Work Order ID 68736

DRAWING NO. D3016	TITLE SEAT FRAME ASSEMBLY	REV. A	DART AEROSPACE LTD ENGINEERING ORDER	D.E.O. NO. D3016-A-1	SHEET NO. SHEET 1 OF 1	SCALE NTS
DRAWN <i>1</i>	CHECKED <i>UP</i>	MFG. APPR. <i>RE</i>	APPROVED <i>WAP</i>	DE APPR. <i>#</i>		
DATE 10.01.29	DATE 10.01.29	DATE 10.01.29	DATE 10.01.29	DATE 10.01.29

PURPOSE:

TO REVISE D3016-11 SADDLE'S HOLE SIZES

D3016-11 SADDLE

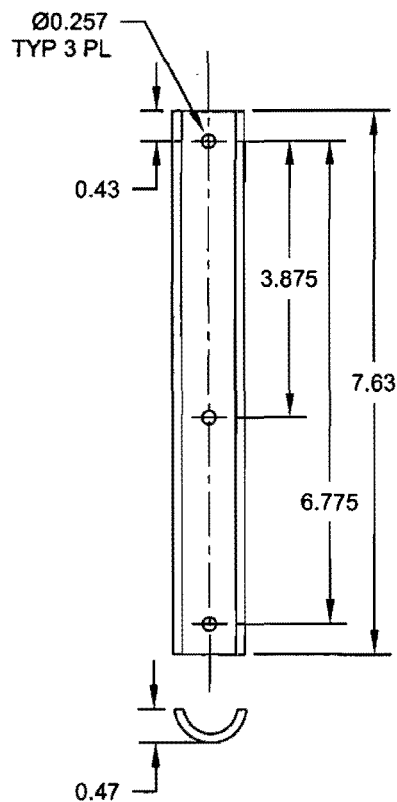
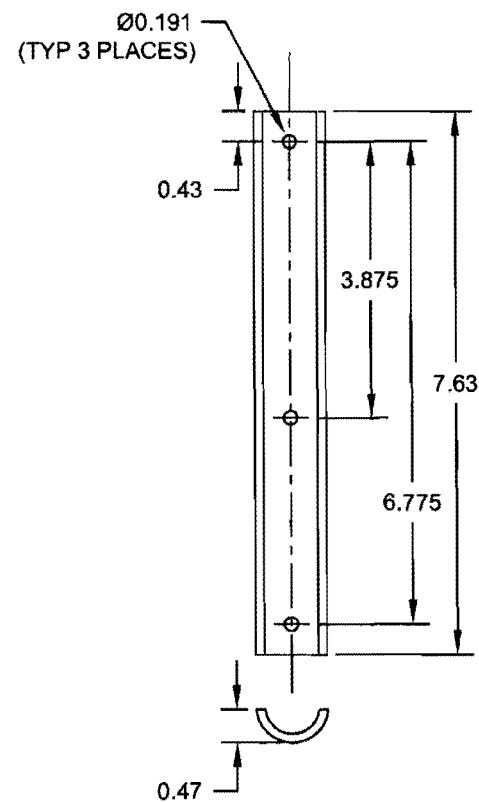
DETAIL D3016-11 SADDLE (SHEET 3): Ø0.257 TYP 3 PL WAS Ø0.191 (TYP 3 PLACES) AS SHOWN:

IS:
